Amend No. 1 to IS 3837 : 1976

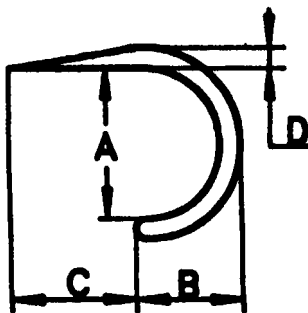
(Page 10, Table 4) — Substitute the following for the existing figure:
